UNITED STATES  
DEPARTMENT OF THE INTERIOR  
BUREAU OF LAND MANAGEMENTFORM APPROVED  
OMB NO. 1004-0135  
Expires: July 31, 2010**SUNDRY NOTICES AND REPORTS ON WELLS**  
*Do not use this form for proposals to drill or to re-enter an abandoned well. Use form 3160-3 (APD) for such proposals.***SUBMIT IN TRIPLICATE - Other instructions on reverse side.**

## Final P&A Procedure Basin Fruitland Coal Formation

**Well:** Marilyn Com #1S  
**SL Location:** 670' FSL & 2580' FEL (SWSE)  
Sec 19, T26N, R11W, NMPM  
San Juan County, New Mexico

CONDITIONS OF APPROVAL

**COLEMAN OIL GAS, INC.  
MARILYN COM #1S PROPOSED P&A**

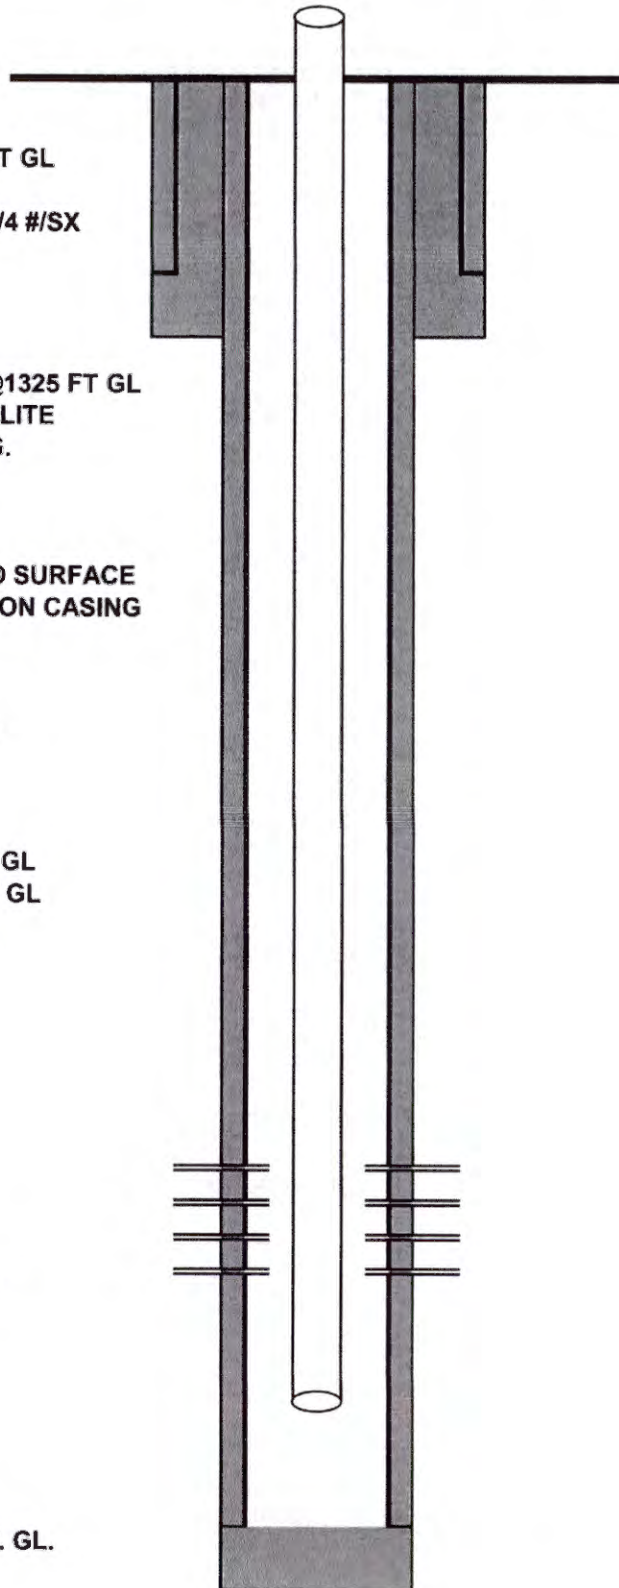
5. Tag with Production Tubing. POOH and Tally Tubing.
6. RIH with Cement Retainer on tubing and set at  $\pm$  1141 FT KB.
7. Place Minimum 10 sacks cement on top of retainer. **Might want to combine Plug #1 & Plug #2, due to close proximity of each other.**

8. Plug #2 Cement Fruitland Top from 878'-928' Inside 4 ½" Casing with 12 sacks neat cement. Plug #2 inside plug based on Long String Cement to Surface. **Might want to combine Plug #1 & Plug #2, due to close proximity of each other.**

- a) Set Plug #1 (1260-1141) ft. to cover the Pictured Cliffs perforations and top. BLM picks top of Pictured Cliffs at 1210 ft.
- b) Set Plug #3 (350-0) ft. to cover the Kirtland and Ojo Alamo tops. BLM picks top of Kirtland at 300 ft. BLM picks top of Ojo Alamo at 163 ft.
